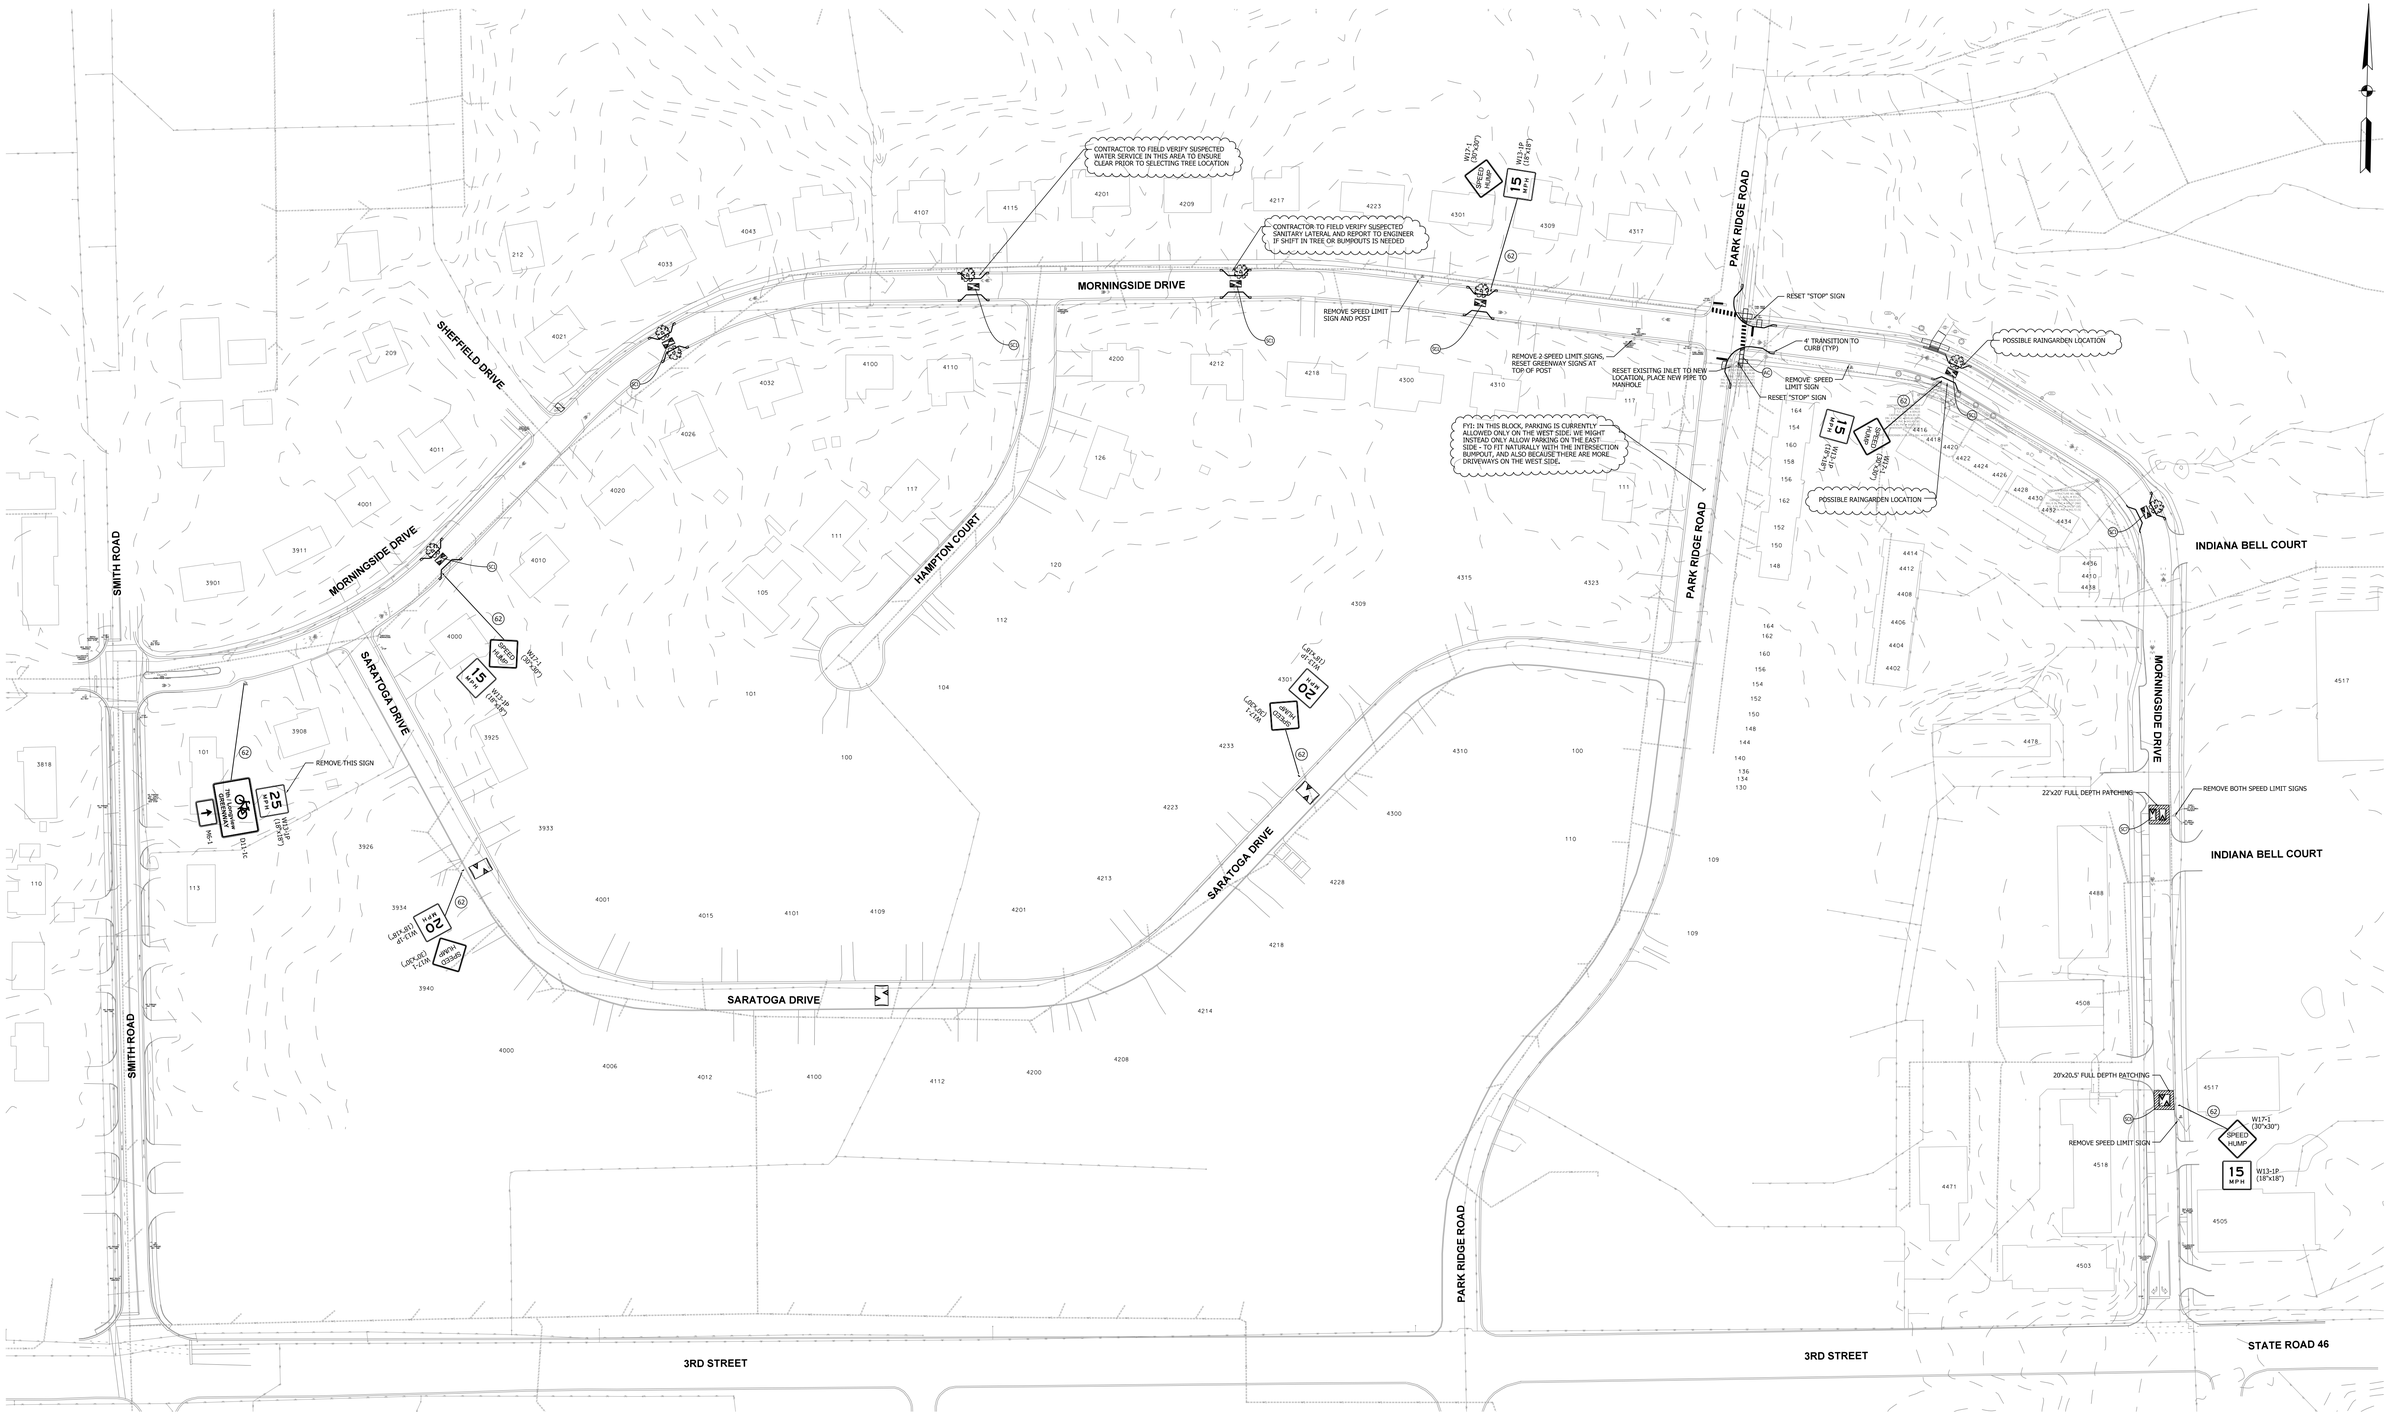
CONTRACTOR TO FIELD VERIFY SUSPECTED WATER SERVICE IN THIS AREA TO ENSURE CLEAR PRIOR TO SELECTING TREE LOCATION
CONTRACTOR TO FIELD VERIFY SUSPECTED SANITARY LATERAL AND REPORT TO ENGINEER IF SHIFT IN TREE OR BUMPOUTS IS NEEDED
MORNINGSIDE DRIVE
SHEFFIELD DRIVE
SMITH ROAD
HAMPTON COURT
SARATOGA DRIVE
PARK RIDGE ROAD
INDIANA BELL COURT
3RD STREET
STATE ROAD 46
REMOVE SPEED LIMIT SIGN AND POST
REMOVE 2 SPEED LIMIT SIGNS, RESET GREENWAY SIGNS AT TOP OF POST
RESET EXISITNG INLET TO NEW LOCATION, PLACE NEW PIPE TO MANHOLE
RESET "STOP" SIGN
4' TRANSITION TO CURB (TYP)
REMOVE SPEED LIMIT SIGN
RESET "STOP" SIGN
POSSIBLE RAINGARDEN LOCATION
POSSIBLE RAINGARDEN LOCATION
FYI: IN THIS BLOCK, PARKING IS CURRENTLY ALLOWED ONLY ON THE WEST SIDE. WE MIGHT INSTEAD ONLY ALLOW PARKING ON THE EAST SIDE - TO FIT NATURALLY WITH THE INTERSECTION BUMPOUT, AND ALSO BECAUSE THERE ARE MORE DRIVEWAYS ON THE WEST SIDE.
REMOVE THIS SIGN

22'x20' FULL DEPTH PATCHING
REMOVE BOTH SPEED LIMIT SIGNS
20'x20.5' FULL DEPTH PATCHING
REMOVE SPEED LIMIT SIGN
SPEED HUMP
W17-1 (30"x30")
W13-1P (18"x18")
15 MPH
20 MPH
25 MPH
W13-1P (18"x18")
W11-2 (30"x30")
W13-1P (18"x18")
W11-2 (30"x30")
W13-1P (18"x18")
W11-2 (30"x30")
